Project: Judge Doyle Podium

File #: 54530 **Version:** 1 **Name:** Awarding Public Works Contract No. 8290, Judge Doyle Podium.

Title: Awarding Public Works Contract No. 8290, Judge Doyle Podium. (4th AD)

Drawn	Date
Author	1/18/2019 4:33:11 PM
Checked By	Drawing Number
Checker	
Approved	
Approver	
Job Number	A-203.2
217-1088

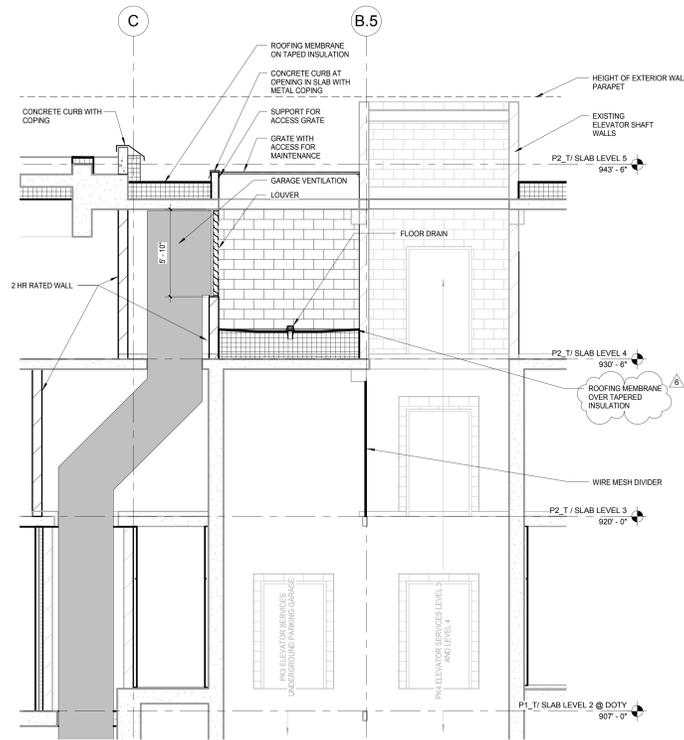
Q10: There are four (4) monitors, mounting brackets, and monitor enclosures within elevator cab interiors shown on drawing A-203.2. Please provide specifications for these items, none is provided.

A-204.1

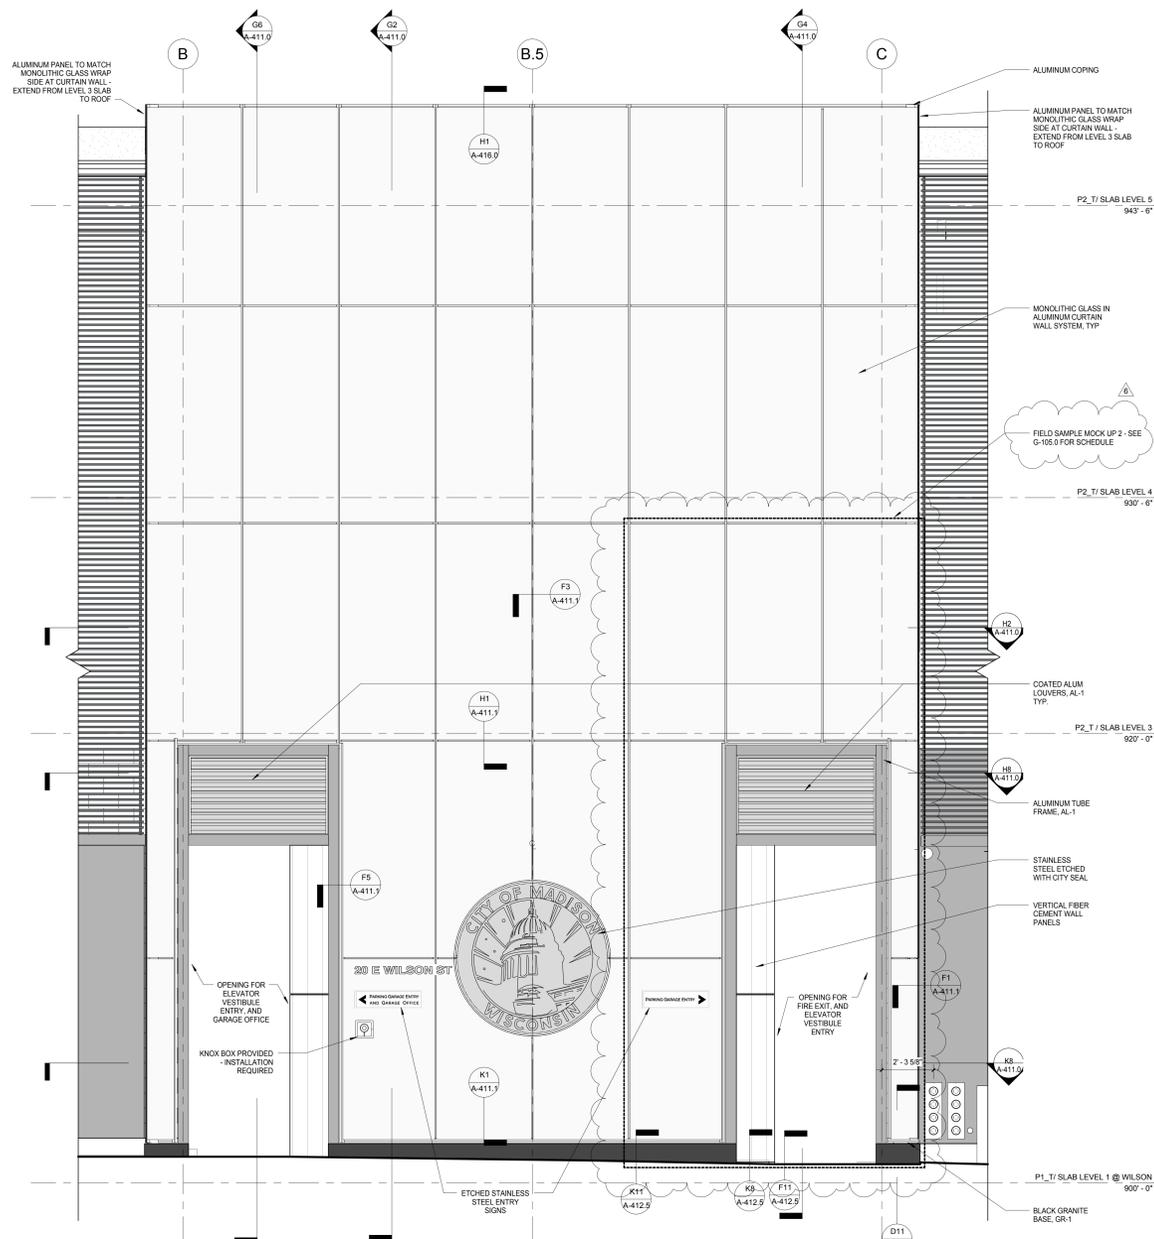
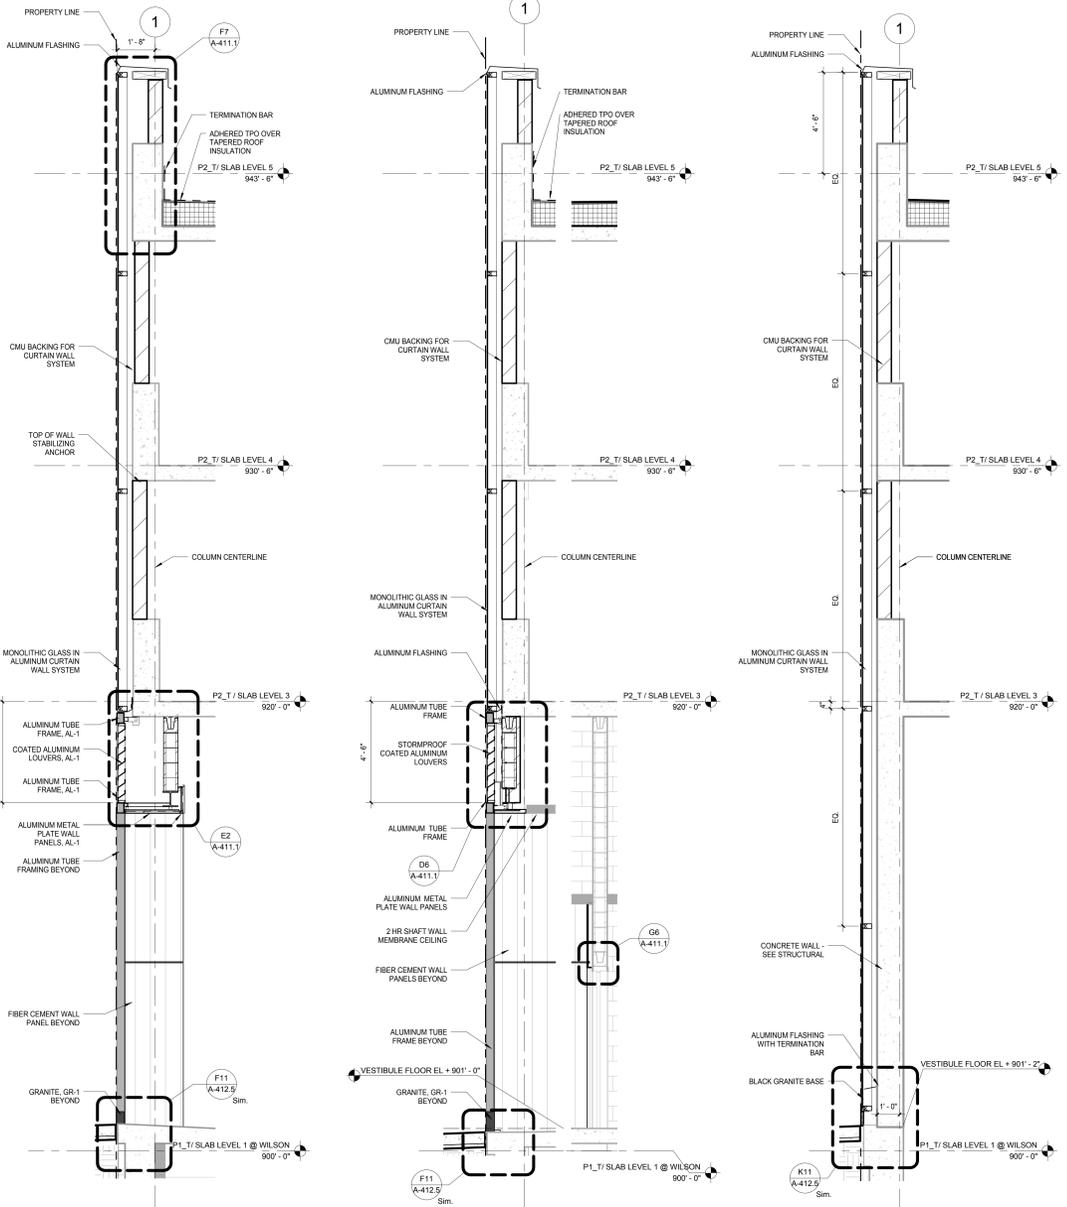
Q29: Detail E8/A-204.1 calls out a wire mesh divider on 3rd floor along B.5 line. This mesh partition appears to be inside the elevator shaft. Please confirm this is correct. Also, please provide a specification for the wire mesh partition.

A411.2

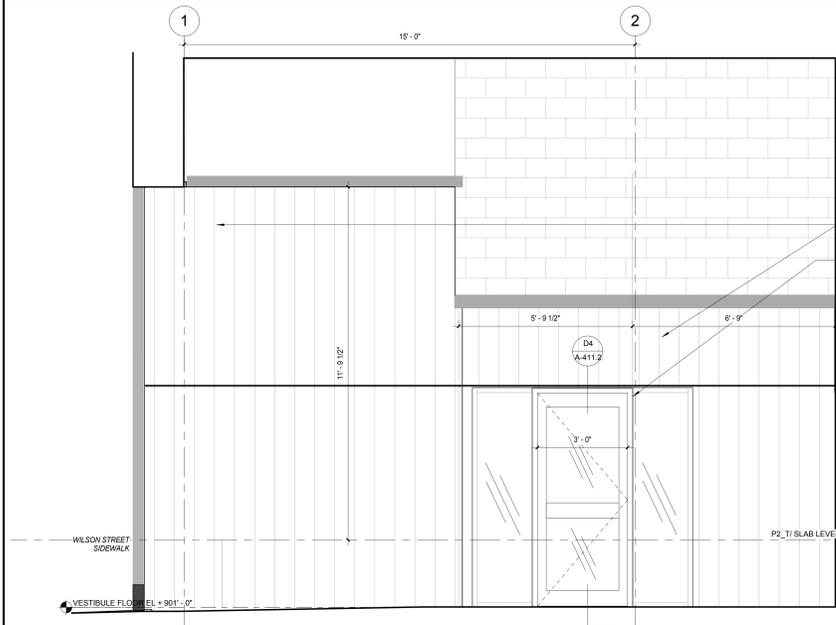
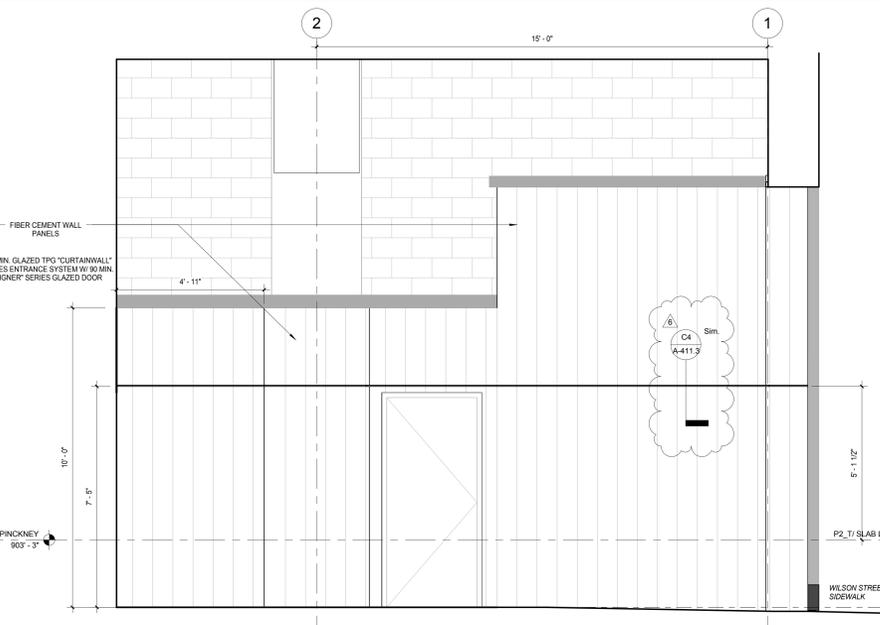
Q33: Elevations D10, D6, and G8 on A411.2 show a dark horizontal line at elevation 908'-4 1/2". Please provide a section through this wall to provide clarify as to what that line represents.

A33: Section marks added on A-411.2 and updated sheet has been included as part of this addendum.

Drawn	Date
Author	1/18/2019 4:35:04 PM
Checked By	Drawing Number
Checker	
Approved	
Approver	
Job Number	A-4120
217-1088

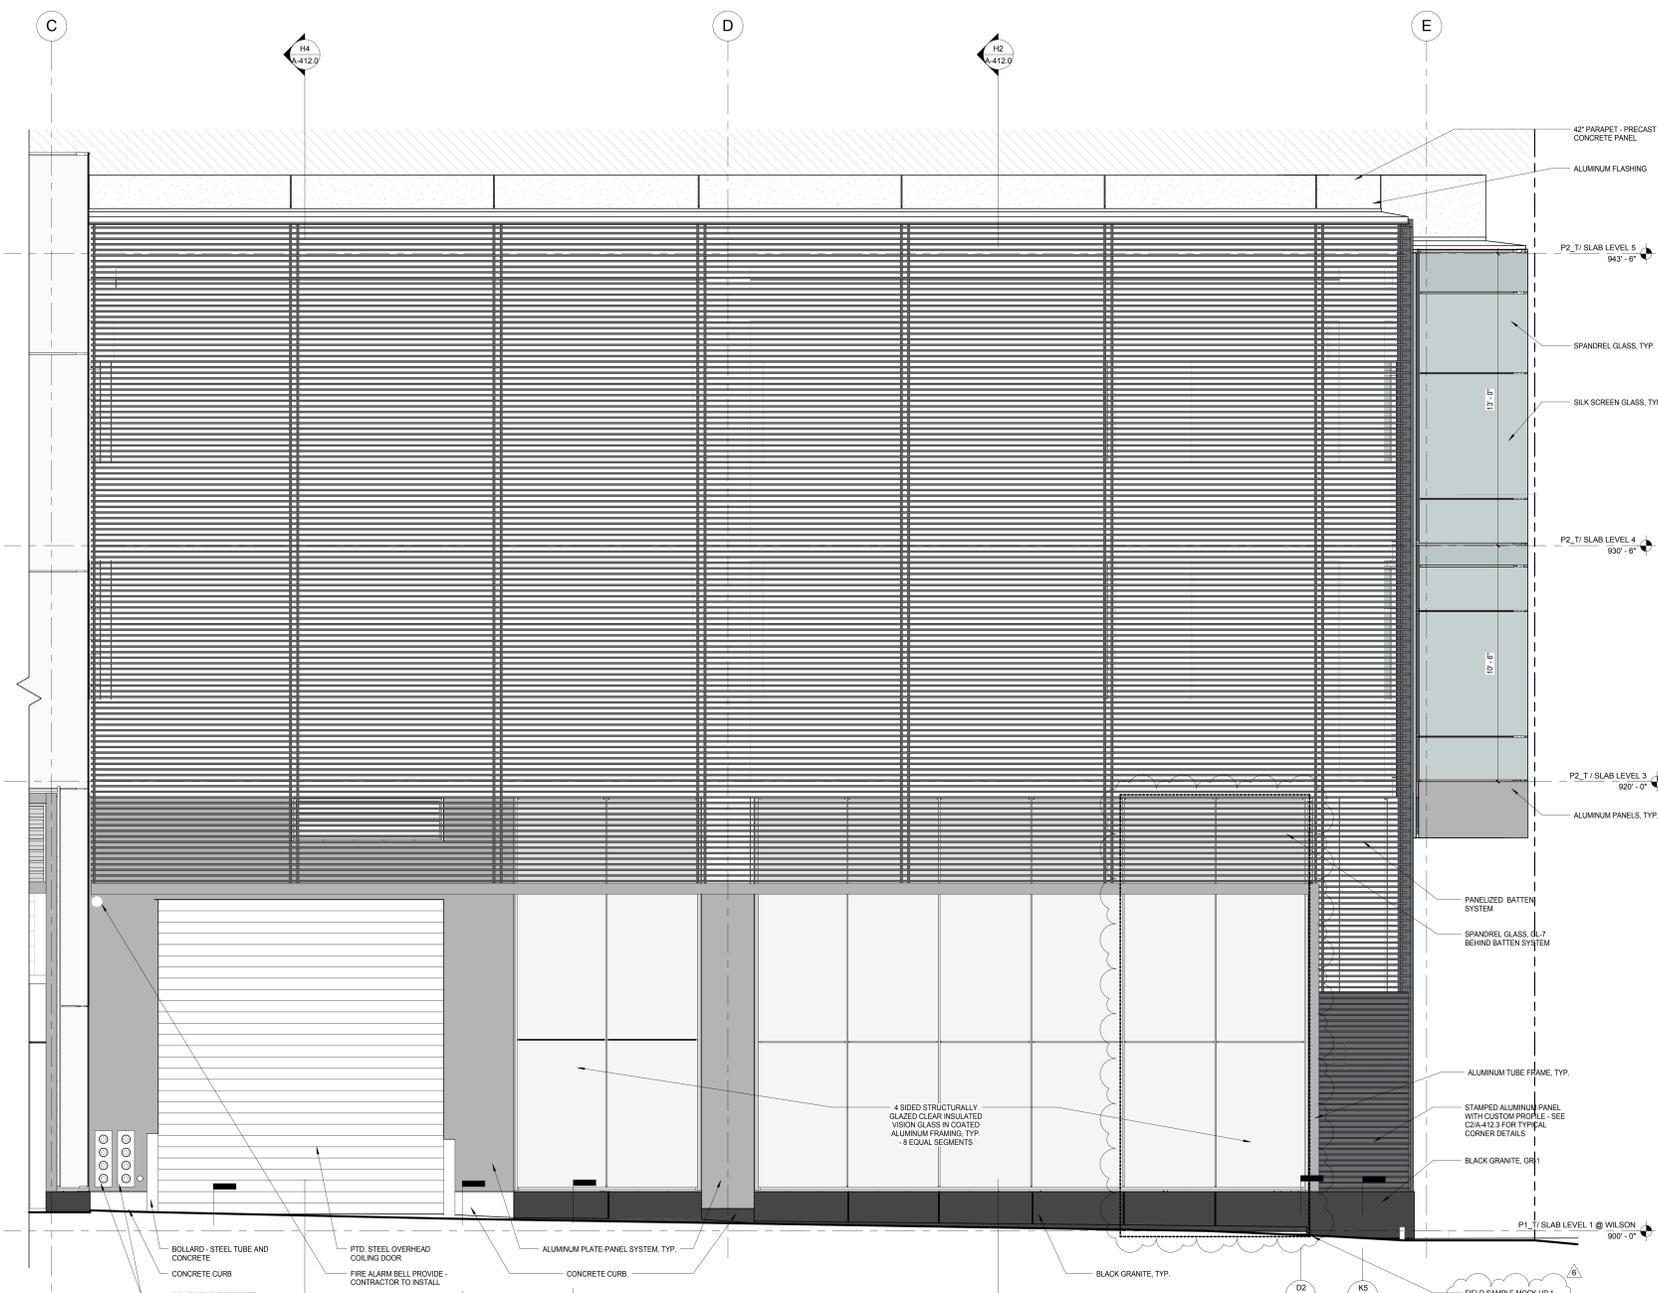
Q32: Detail K8/A-412.5 shows continuous stainless steel flashing at fiber cement panels on the exterior face of the building. Please clarify if the stainless flashing should be installed at the base of all fiber cement panels or only where they occur at the exterior of the building.
